ADDENDUM NO. 5

DATE: April 3, 2020

PROJECT: ITB 20343
BETHUNE POINT WATER RECLAMATION FACILITY
GENERATOR REPLACEMENT

S-101

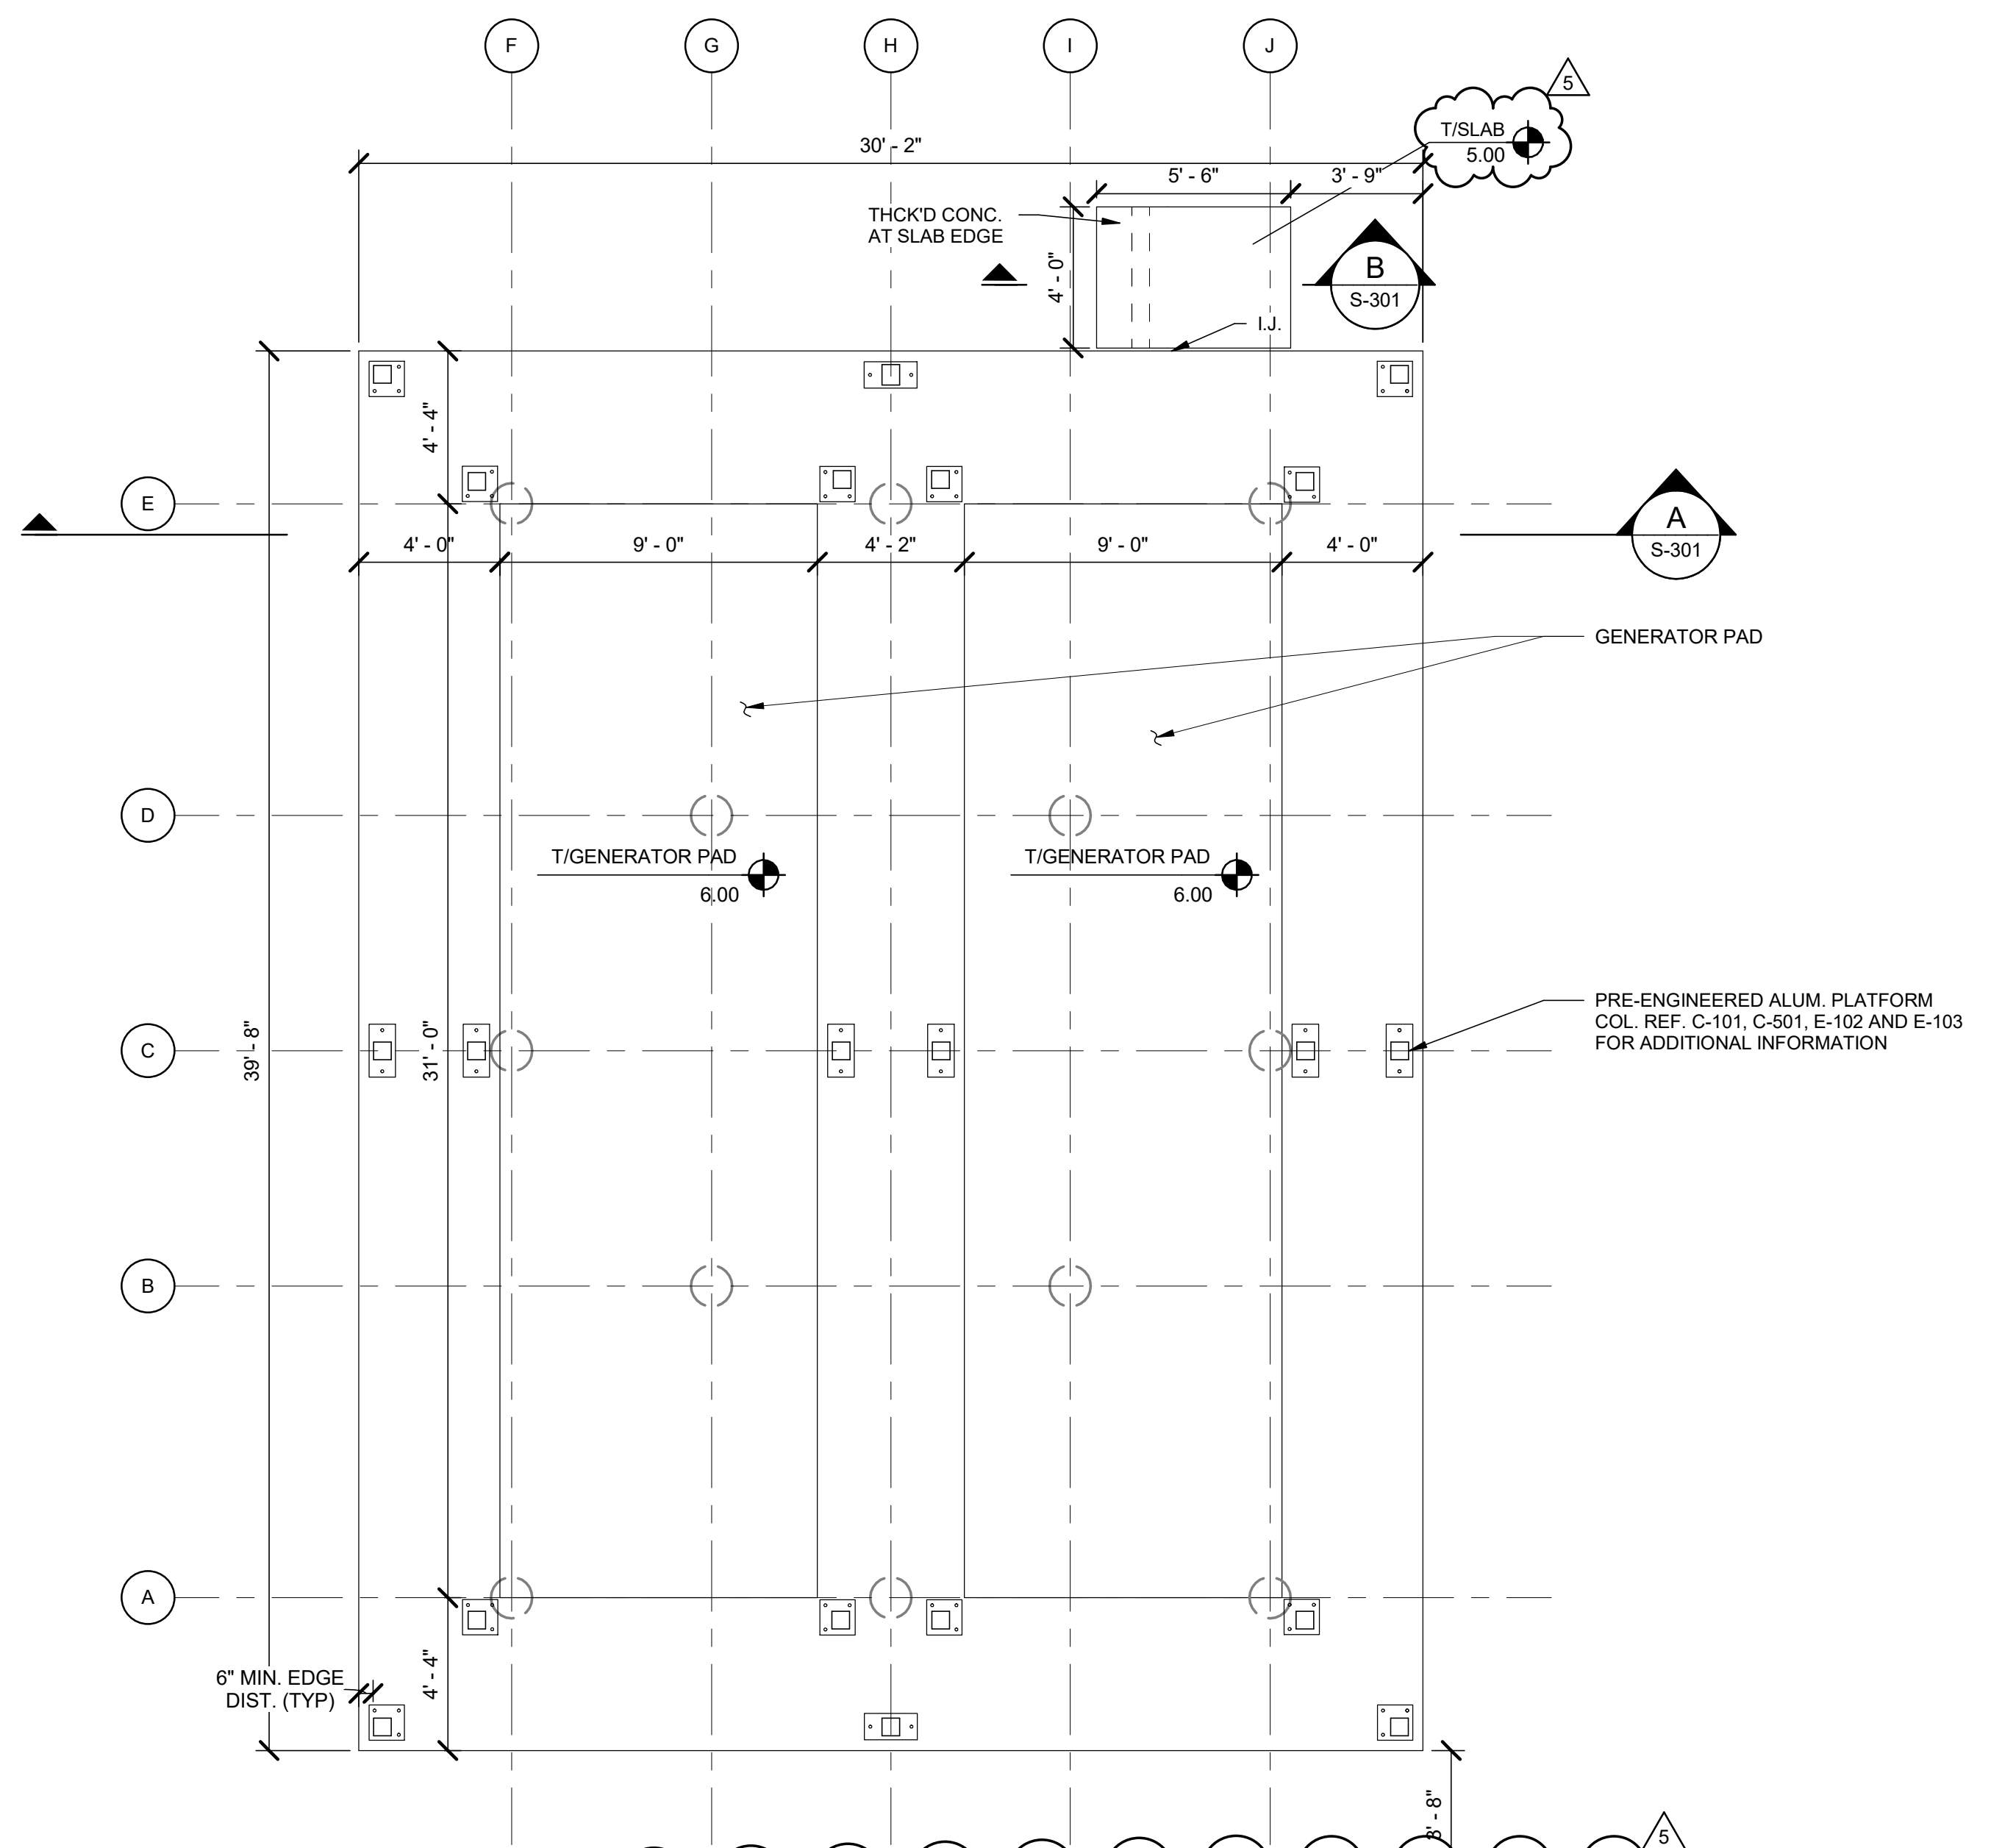
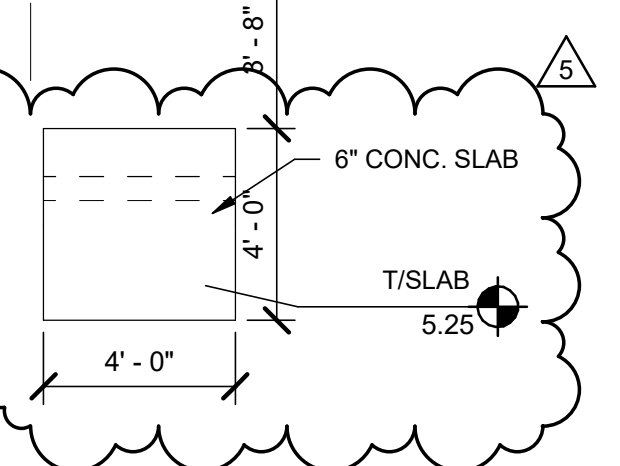
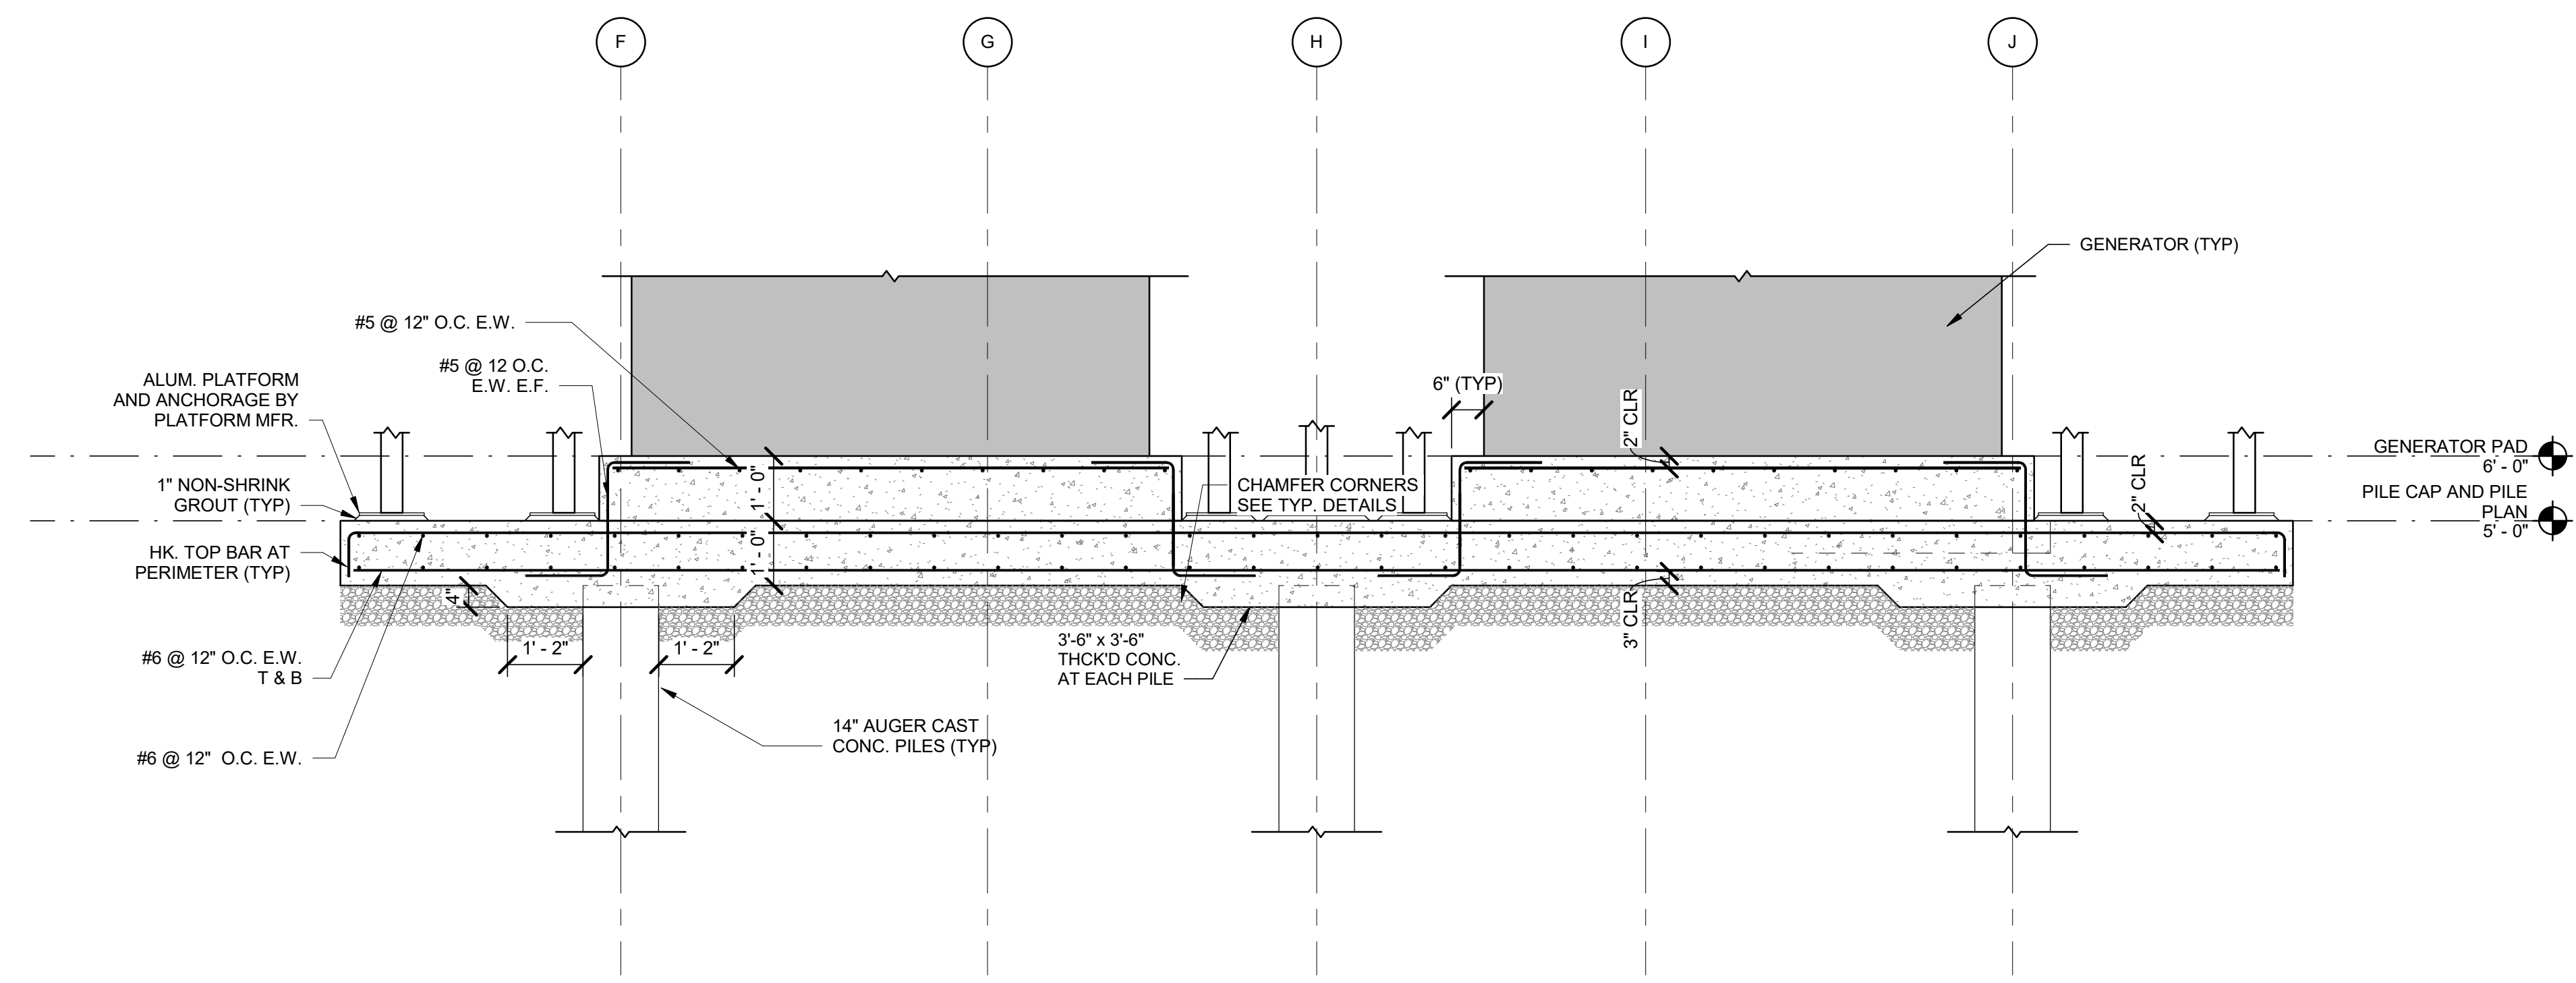
B. Please see revised Sheets S-101 and S-301 attached. Revisions are highlighted by clouds.
